Accredited Standards Committee
X3, Information Processing Systems

Doc: X3T10.1/96a143R0
Date: May 16, 1996
Project: 1147D
Ref Doc.: X3T10.1/1147D rev 0
Reply to: Mark DeWilde

Subject: Resurrection of Longer full speed Link proposal

Figure 8 - Specific frame format

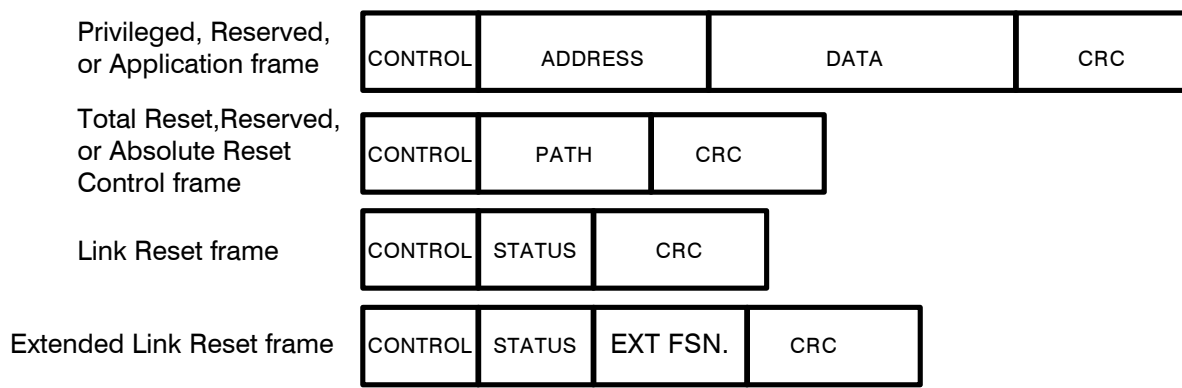
The recommendation Ed made on the Frame Sequence Number bit field width is well taken. Since both frames and acknowledges can be lost in a link fault situation, both ports need to synchronize on the frame number to be resent and acknowledged. Since there can be many frames in the pipeline, the FSN/RSN counters may roll over multiple times. This makes for a difficult recovery at best. For these counters, I also recommend 16 bits of width. For ports that have this capability, the link reset frame is extended by two additional bytes, which carry the full 16 bit counter value. The format of the first link status byte remains unchanged.
